**Paul A. Harden**  
Site Vice President724-682-5234  
Fax: 724-643-8069September 28, 2010  
L-10-115

ATTN: Document Control Desk  
U. S. Nuclear Regulatory Commission  
Washington, DC 20555-0001**SUBJECT:**Beaver Valley Power Station, Unit Nos. 1 and 2  
BVPS-1 Docket No. 50-334, License No. DPR-66  
BVPS-2 Docket No. 50-412, License No. NPF-73  
Response to Request for Additional Information Related to Generic Letter 2004-02  
(TAC Nos. MC4665 and MC4666)

1. Response to Request for Additional Information Regarding the Supplemental Responses to Generic Letter 2004-02 for Beaver Valley Power Station Unit No. 1 (BVPS-1) and Unit No. 2 (BVPS-2)
2. Regulatory Commitment List

Response to Request for Additional Information Regarding the Supplemental Responses to Generic Letter 2004-02 for Beaver Valley Power Station Unit No. 1 (BVPS-1) and Unit No. 2 (BVPS-2)  
Page 1 of 132

Figure 3-1, BVPS-2 Reactor Cavity Insulation and Neutron Shield Details

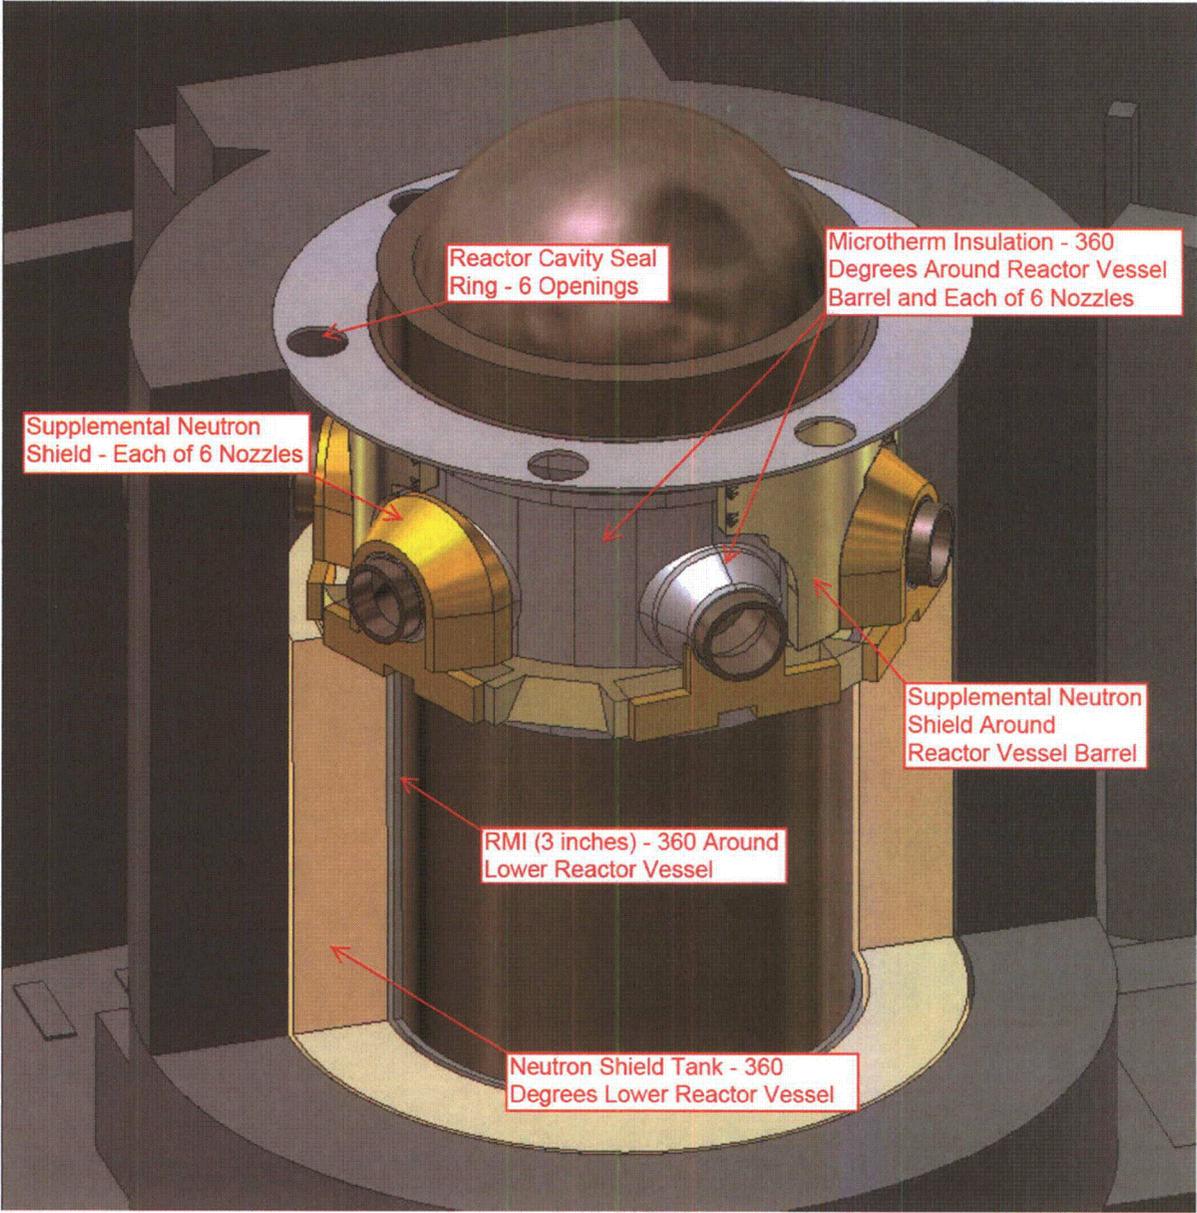
**Please provide additional details and assumptions on the alternate ZOI calculated for the Microtherm insulation installed on the RCS for BVPS-2, to describe how the ZOI was adjusted for the confined space within the reactor annulus. In Reference 1, it is stated that the alternate ZOI was calculated using the Boiling Water Reactor Owners Group Utility Resolution Guidance method 3 for restrained**

**breaks and was adjusted for the confined volume in the reactor annulus. Please provide details on the installation of the piping, insulation, and other structures or components that could affect the calculation, including how the axial and radial offsets were determined for the piping, the location of the insulation relative to the piping, pipe wall thickness, postulated break locations, whether longitudinal pipe breaks were considered, the destruction pressure used for the evaluation, etc. Please discuss whether a pancake-shaped jet as described in ANSI/ANS-58-2-1988 was evaluated, justify that a spherical ZOI is appropriate for the postulated restrained break, or describe how the jet was evaluated to behave within the confines of the reactor annulus. Provide information that describes how the amount of Microtherm debris would change with respect to the size of the ZOI. A non-conservative treatment of Microtherm would likely result in non-conservative head loss inputs. The Microtherm head loss is the bounding case for BVPS-2.**

The June 30, 2009 supplemental response (Reference 1) stated that the alternate ZOI was calculated using the Boiling-Water Reactor Owners Group Utility Resolution Guide (URG) Method 3 for restrained breaks and was adjusted for the confined volume in the reactor annulus. This alternate ZOI development method is being replaced by the American National Standards Institute ANSI/ANS 58.2-1988 standard methodology for assessing a jet profile impact on the Microtherm<sup>®</sup> insulation around the reactor pressure vessel and reactor coolant pipe nozzles. Therefore, the following information, as it pertains to the determination of an alternate ZOI, supersedes the determination of an alternate ZOI using Boiling-Water Reactor Owners Group URG Method 3.

The location of the Microtherm<sup>®</sup> insulation and the design configuration of the reactor coolant loop piping penetrating the reactor cavity wall are shown on Figure 3-1 and

A destruction pressure of 40 pounds per square inch is used for the Microtherm<sup>®</sup> insulation based upon a 4D ZOI. The basis for this pressure is provided on Attachment 1, page 20 of the June 30, 2009 supplemental response.

Figure 4-1, Benelex® Shield Ring Location

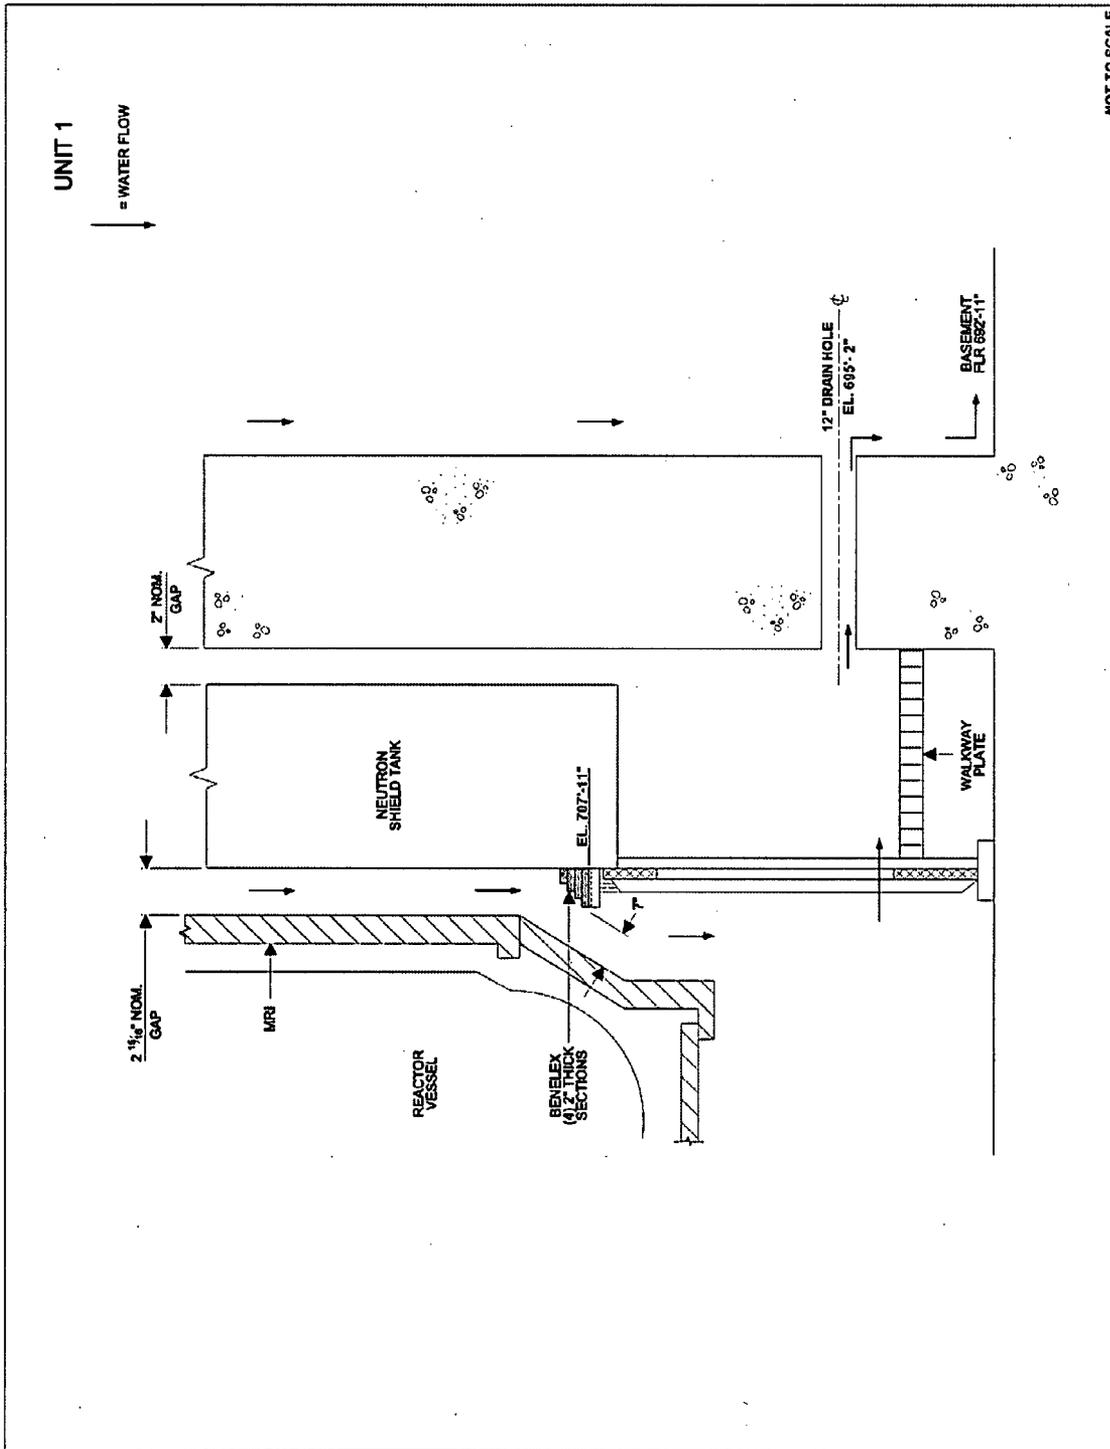
**In Reference 1, it is stated that Benelex 401 is a high-density wood-based material composed of cellulose and lignin fibers. The response stated that the material was evaluated for seismic forces and loss-of-coolant accident (LOCA) pressure loading, but did not specify the assumptions for the evaluation. It was not clear that the evaluation considered all aspects of impingement from a LOCA steam jet. Please provide additional information for the evaluation that determined that the ZOI for Benelex 401 would be limited to 2 diameters (D). Please describe the methodology and assumptions for this evaluation. State whether any testing was performed to determine the appropriate destruction pressure for the material. If testing was conducted provide adequate information to justify that the testing was representative of, or bounded, the conditions that would be expected in the plant at the assumed ZOI. State whether the material is considered to be water soluble. If so, please provide information that justifies that the material would not fail due to the post-LOCA environment and potentially transport to the strainer.**

This question is only applicable to BVPS-1. BVPS-2 containment does not contain any Benelex<sup>®</sup> shielding. FENOC has thoroughly evaluated Benelex<sup>®</sup> 401 and found it to be a hard, stable material that will withstand the initial impulse pressure of a reactor pressure vessel (RPV) Nozzle LOCA blowdown, as well as the mildly alkaline water spray/cascade of the post-LOCA environment at BVPS-1 without degradation over 30 days. No chemical compounds would be expected to form as a result of this exposure.

Benelex<sup>®</sup> is used as a supplemental neutron shield near the bottom of the reactor vessel at BVPS-1, approximately 23 feet below the reactor vessel nozzles. The shield is comprised of four layers of two-inch thick Benelex<sup>®</sup> material shaped in the form of a large ring. The material is bolted together and supported by structural steel (as shown in Figure 4-1). The Benelex<sup>®</sup> shield ring does not perform any structural function. The material characteristics of Benelex<sup>®</sup> are described in detail in Section 3 of Appendix III to this RAI response attachment.

Figure 7-2 Waterbox Velocity Plot for BVPS-1

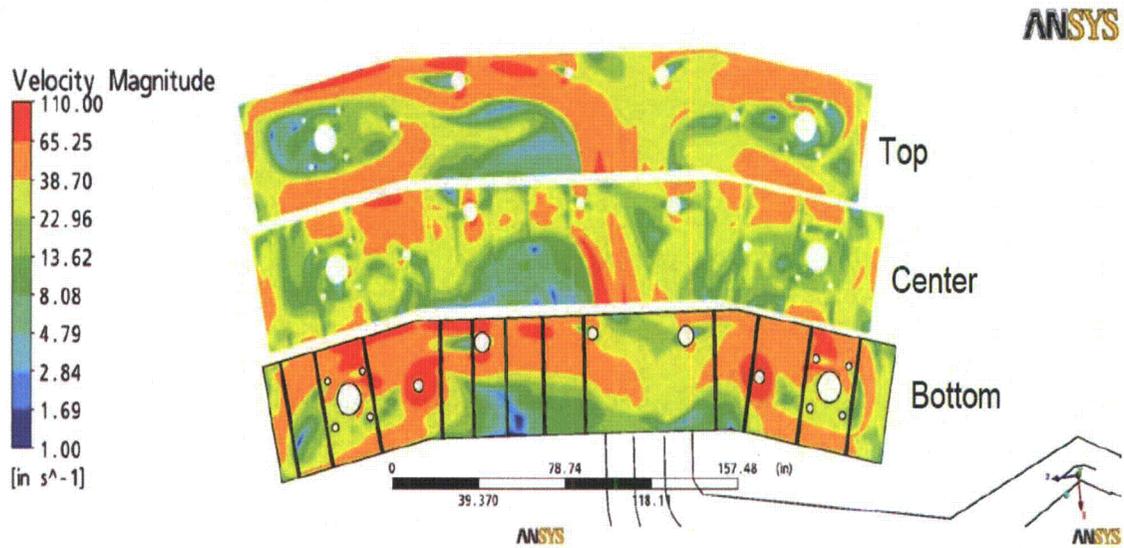
**fluid prior to reaching the pump suction. The mechanism for the absorption of the gases was not understood by the NRC staff. It was not clear whether the gases could collect as bubbles in the strainer or piping and eventually transport to the pump suction. It was also not clear that the gases would absorb into the liquid prior to reaching the pump suction. Please provide the assumptions and methodology for the evaluation that predicted the final void fraction at the pump suction.**

For BVPS-1, the flow rate to each pump from the waterbox is dependent on the assumed single failure and the mode of operation (before or after safety injection recirculation). Prior to transfer to safety injection recirculation, either two or four Recirculation Spray pumps will be taking suction from the waterbox depending on single failure assumptions. Following transfer to safety injection recirculation, one or two Low Head Safety Injection Pumps as well as two Recirculation Spray pumps will take suction from the waterbox. Based on the deaeration calculations performed as described above, the only flow cases that result in air evolution in the strainer or waterbox are those associated with maximum flow conditions. These cases result from the assumption of no single failures. Since all cases resulting in air evolution occur prior to safety injection recirculation, all four RSS pumps must be operating to achieve maximum flow conditions.

Air bubbles will be formed primarily in the debris bed and the strainer modules upstream of the duct connecting the modules to the waterbox. The velocities internal to the strainer modules are high enough to sweep the air bubbles into the waterbox. The ability of air bubbles to remain in the flow stream is addressed using streamlines produced as part of the computational fluid dynamics (CFD) analysis of the waterbox created for the strainer head loss computation. Figure 7-1 shows a layout of the BVPS-1 waterbox and the location of the suction piping to the pumps from the waterbox. The velocity distribution plots show the flow of water from the duct, which then splits in the waterbox to the pump suction inlet pipes. Figures 7-2 and 7-3 show the CFD results for the case that is representative of those cases where voids are generated. This case corresponds to operation prior to transfer to safety injection recirculation where four Recirculation Spray pumps are in operation. Based on the plots shown in Figures 7-2 and 7-3 below, there is a clear movement of water entering the waterbox from the duct to the emergency core cooling system (ECCS) pump suction pipes, with velocities in the top region of the waterbox of 1.5 in/s or more. Some small areas are slightly below this velocity. These areas are inconsequential since surrounding areas have higher velocities and will tend to sweep air bubbles into the flow stream.

Figure 19-1, BVPS-2 August 2009 Test 2 Differential Pressure and Velocity Versus Time, Flow Sweep Portion

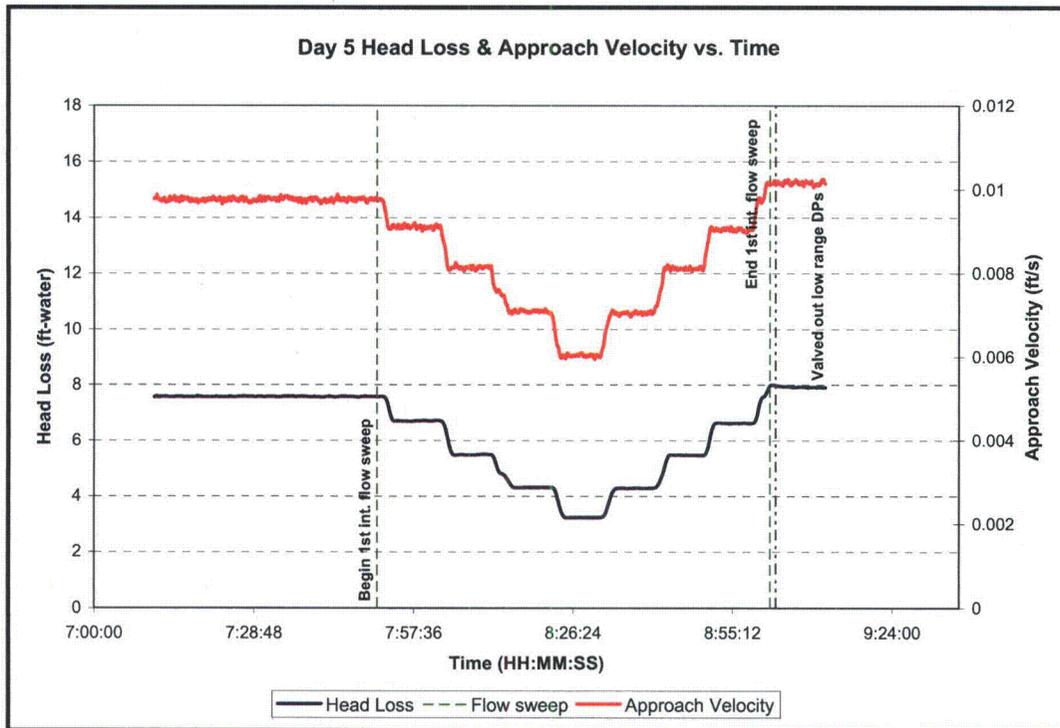
**The head loss graph, Figure 3.o.2.17-7 in Reference 1, shows that a flow sweep was conducted prior to the final debris addition and prior to the test reaching a stable value. Please provide the basis for this test sequence. Please provide information that justifies that the flow sweep did not affect the head loss result non-conservatively.**

In the June 30, 2009 supplemental response, Figure 3.o.2.17-7 shows a supplemental debris addition after the flow sweep. The flow sweep was conducted after the total design basis debris load had been added (non-chemical and chemical debris loads) and

Additionally, Figure 3.o.2.17-7 is applicable to BVPS-2 Test 5. At the time of the June 30, 2009 supplemental response, Test 5 represented the head loss for the reactor vessel nozzle break and bounded the maximum allowable Microtherm<sup>®</sup> debris load. However, as discussed in Appendix I of this RAI response attachment, BVPS-2 August 2009 Test 2 now represents the head loss for the reactor vessel nozzle break and bounds the maximum allowable Microtherm<sup>®</sup> debris load. Therefore, BVPS-2 Test 5 is superseded by the BVPS-2 August 2009 Test 2 and is no longer a design basis test.

Figure 19-1 provides the BVPS-2 August 2009 Test 2 Differential Pressure and Velocity Versus Time for the portion of the test when the flow sweep was performed following all debris additions.
